Below are our responses in red to your review comments dated 05.12.21 for our 6129 Woodbine Way project. We have attached the updated sheets with the revisions.

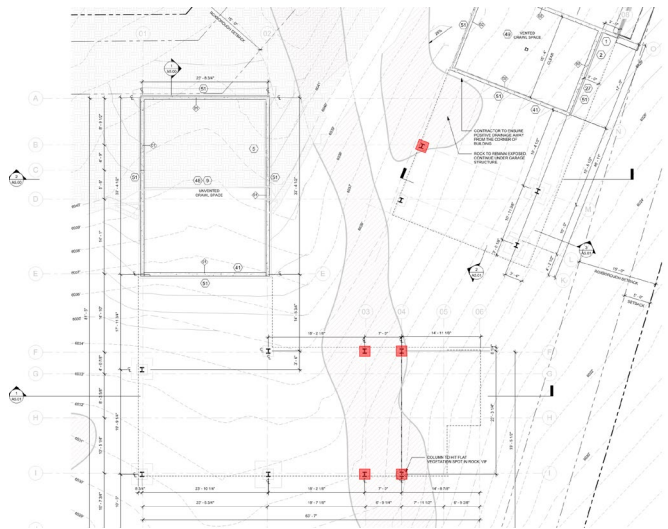
*3. Per Section 4.6, Siding: No greater than 6" exposed concrete foundations permitted at columns.*

We have revised our call outs on our column to concrete foundation on detail 5/ A8.00 to clarify that the exposed concrete at column soil bearing locations shall not exceed 6". Where our columns hit rock, structural will need to have the minimum be 6" which due to the rock slope will potentially make some instances be a few inches more than the 6" on the opposite side. See detail 5 on sheet A8.00. We have added a note that in areas that exceed the 6", we are proposing to paint to match the onsite rock color. The maximum number of locations we anticipate this at is 5 of the 12. See diagram with locations marked in red for reference below.
